Addendum to IFB

IFB NUMBER: IFB 22-074/JW

IFB TITLE: Mesquite Point Public Boat Ramp

ADDENDUM NO.: 2

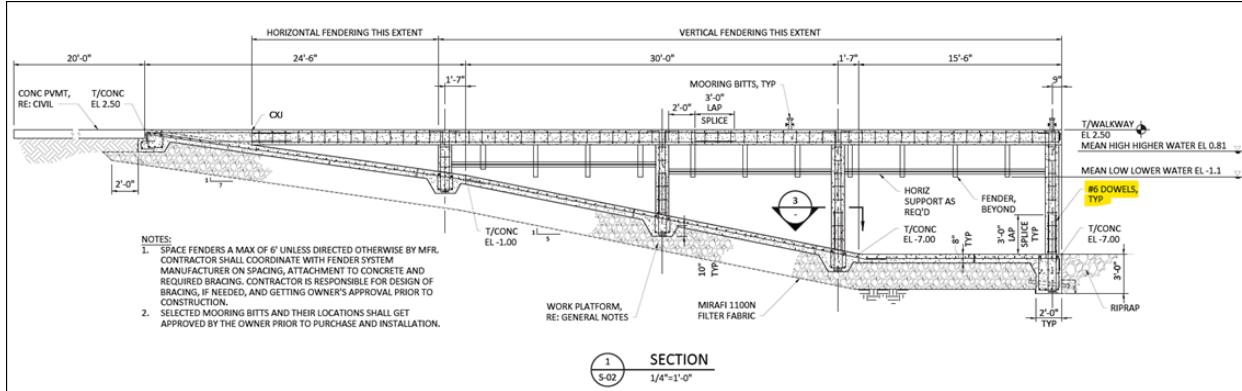
QUESTION: For the walls of the ramp, how long are the L bars (steel) that will tie to the footer? At the center column, please clarify how it ties to the slab.

ANSWER: Sections 1 & 2 in sheet S-04 show how walls and columns connect to the foundation. Both have dowels which are the L bars mentioned in the question.

For the columns, the following section is highlighted where dowels are found:

BRIDGE LAYOUT

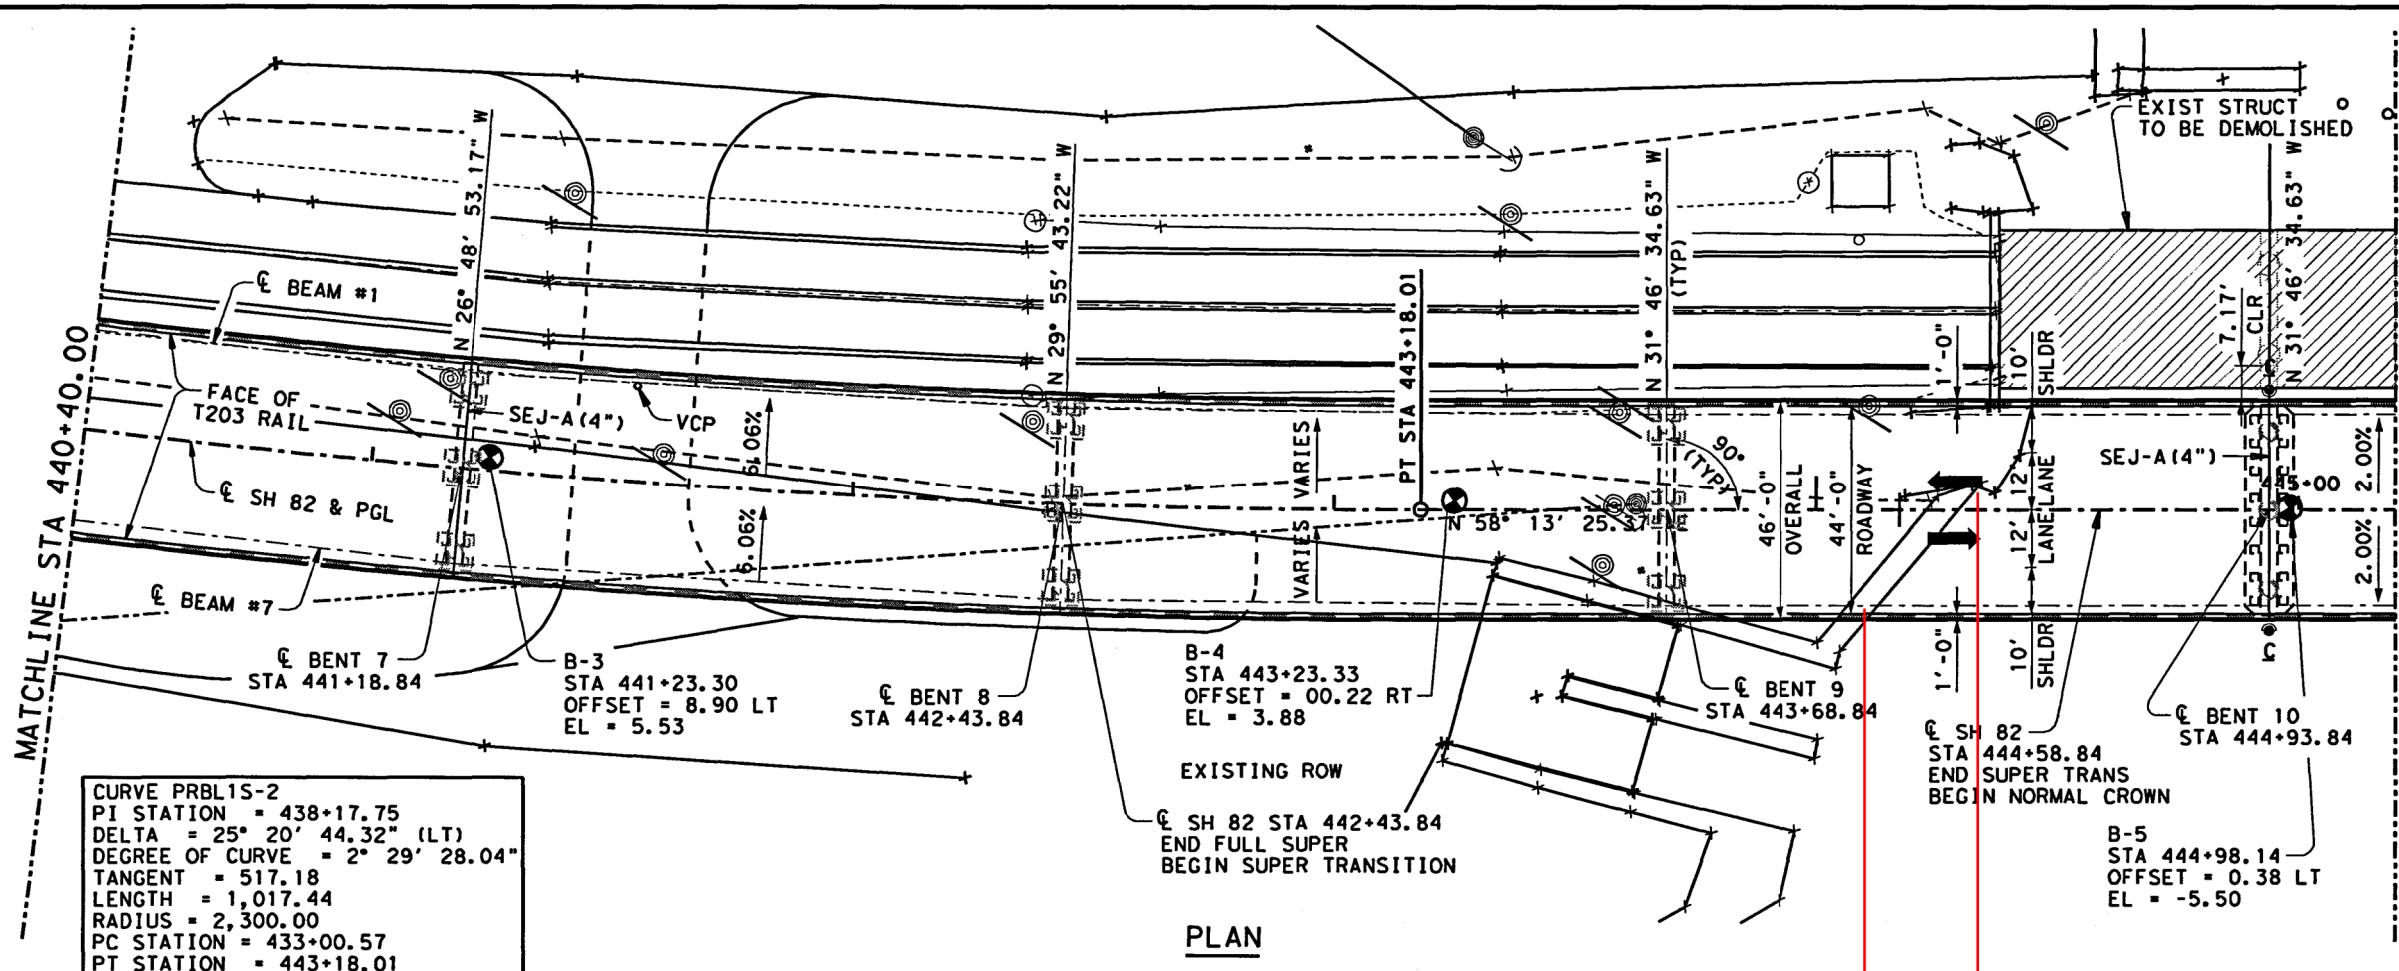
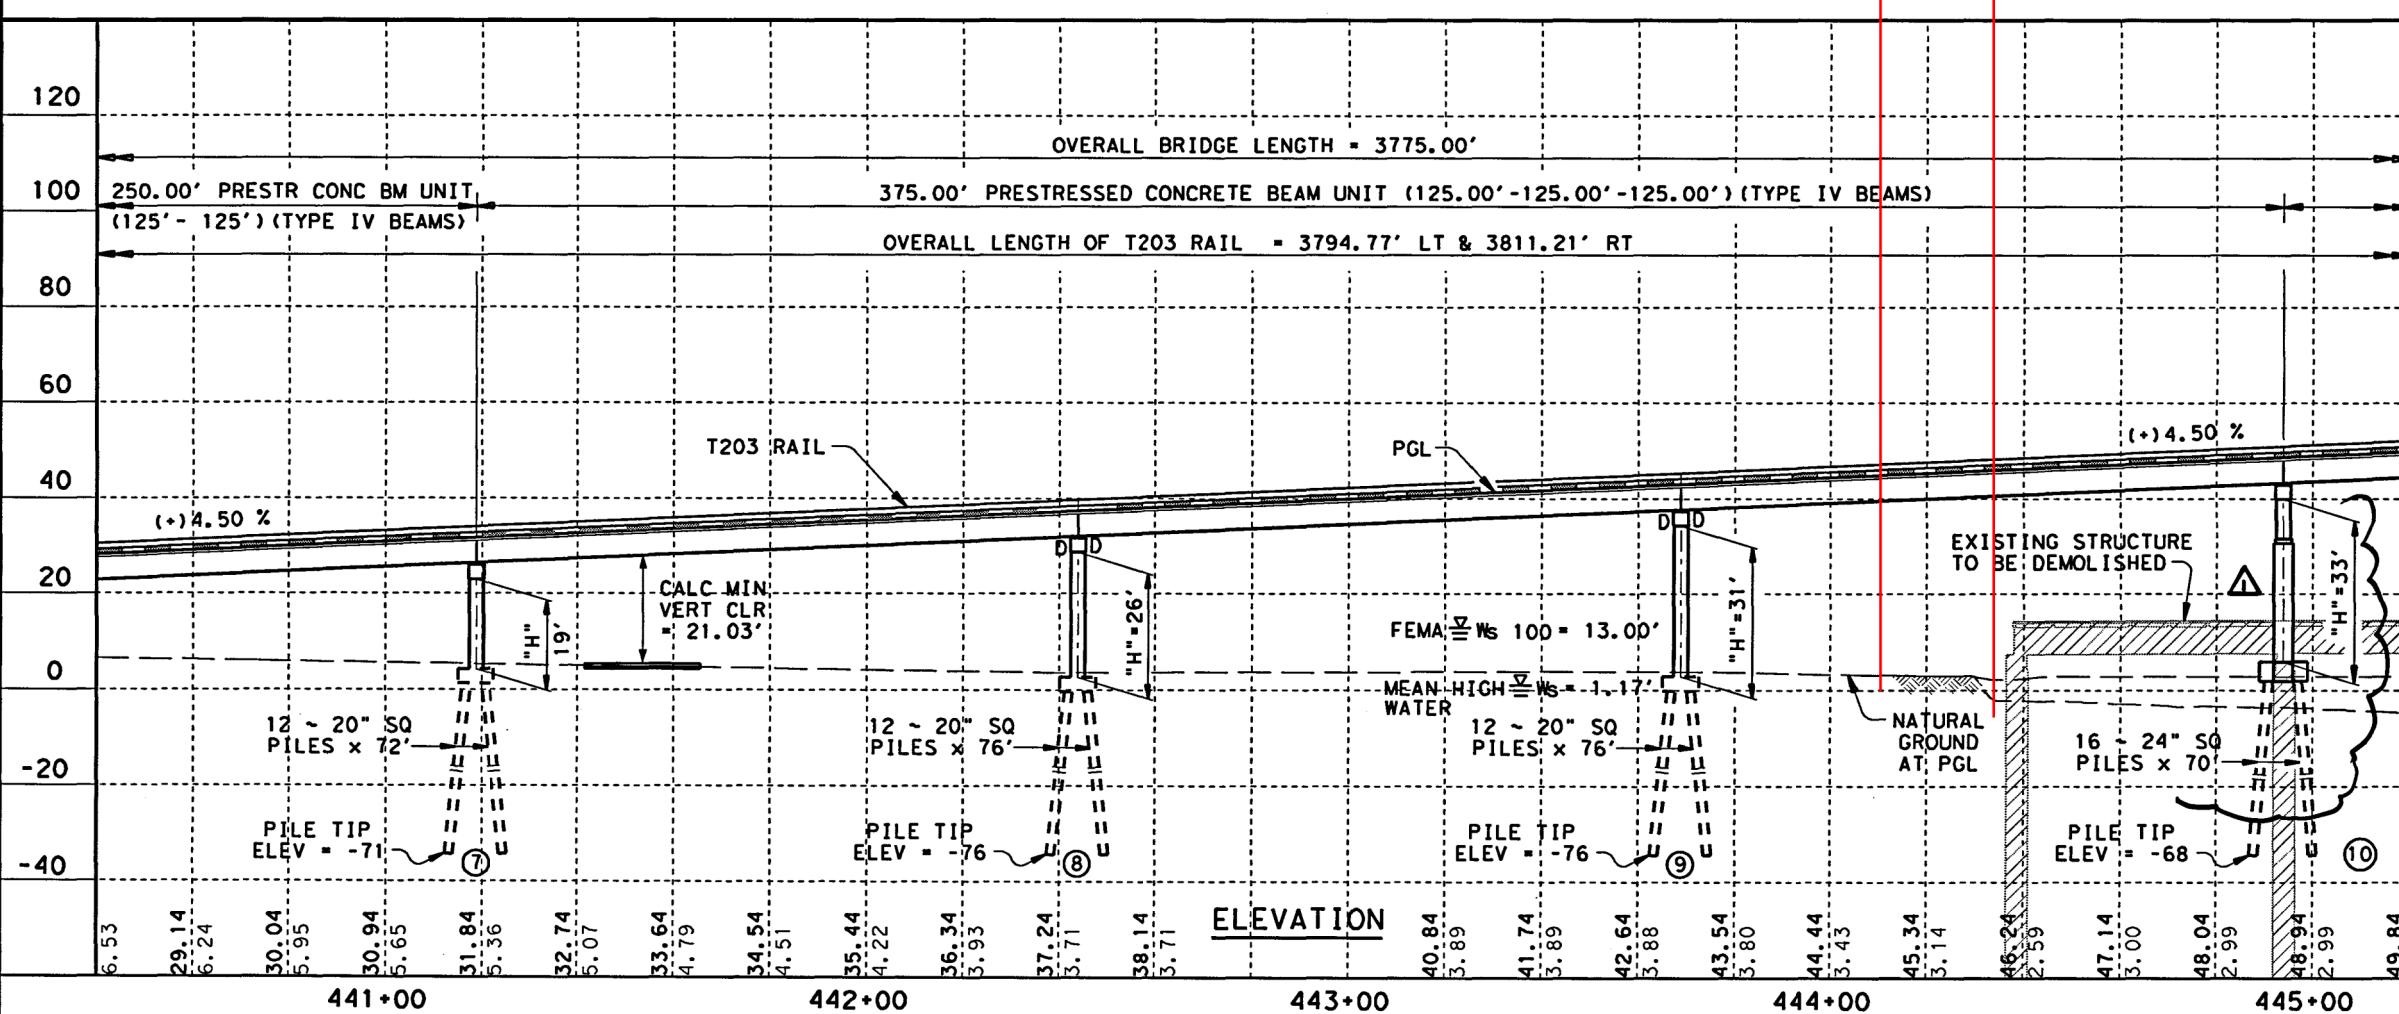
QUESTION: What is vertical clearance at the bridge to sheet pile location?

ANSWER: The vertical clearance at the bridge to sheet pile location under State Highway (SH) 82 is between approximately 36 ft and 37 ft without including adjacent depth to the Sabine Pass bottom, according to the Attachment 1 excerpt from the 2007 TxDOT SH82 reconstruction plans, where we've added red lines to show the extent in plan and profile view for sheet pile installation under SH82. Adjacent depth to Sabine Pass bottom is approximately 4 ft. Bidders should field verify the clearance to their own satisfaction for planning the means and methods for driving sheet pile under SH82 prior to such work.
